Amendments to the Drawings:

REMARKS/ARGUMENTS

Appl. No. 10/037,278
Amdt. dated May 25, 2006
Reply to Office Action of January 25, 2006

FIG. 5A

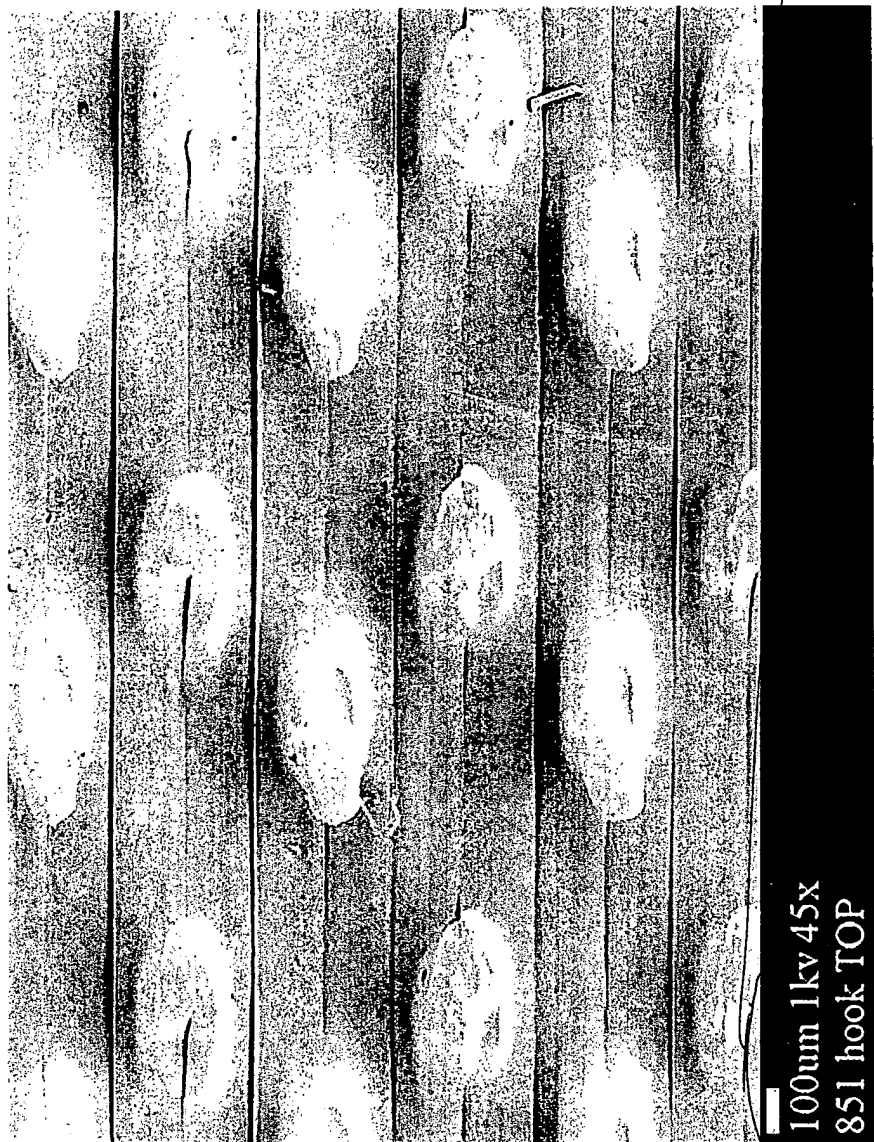
Next the Examiner objects to Figs. 5A, 5B, 6 and 7 on the basis that descriptive text should be avoided. Applicants respectfully point out that corrected photomicrographs were

removed

As can be seen, Figs. 5A, 5B, 6 and 7 as submitted herewith, and with the amendments of January 15, 2004 and July 28, 2004 clearly do not have any descriptive text. Therefore, Applicants respectfully request that the Examiner withdraw the objections to the drawings for the reasons set forth above.

FIG. 5B

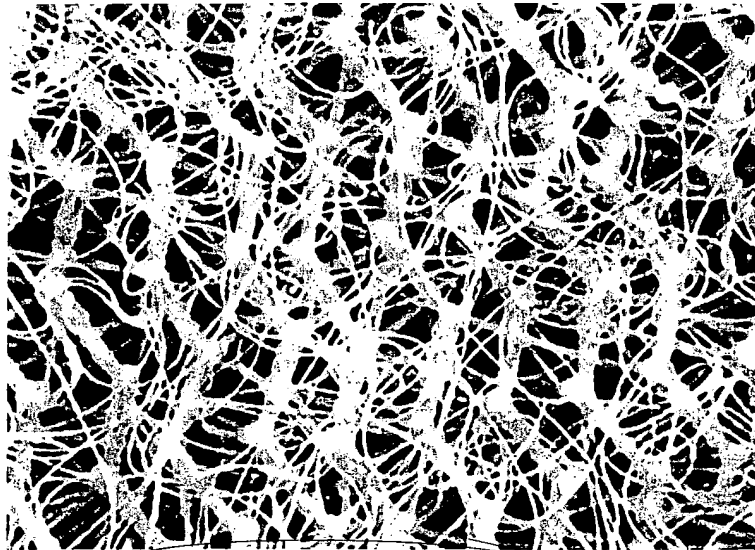
Remove

Guilford Woven Loop

FIG. 6

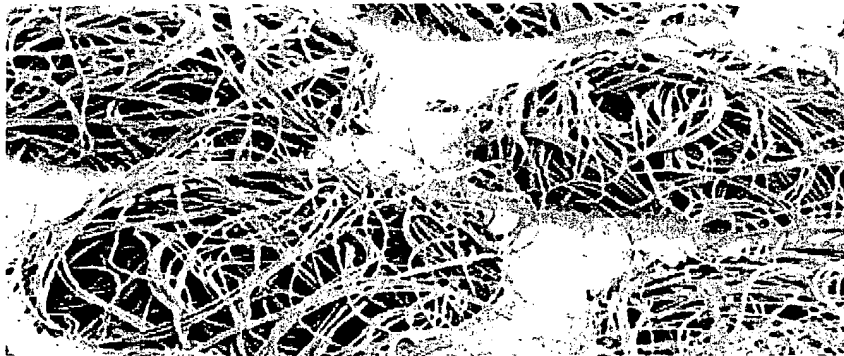
Remove

Nonwoven PUB Loop Dots

Remove
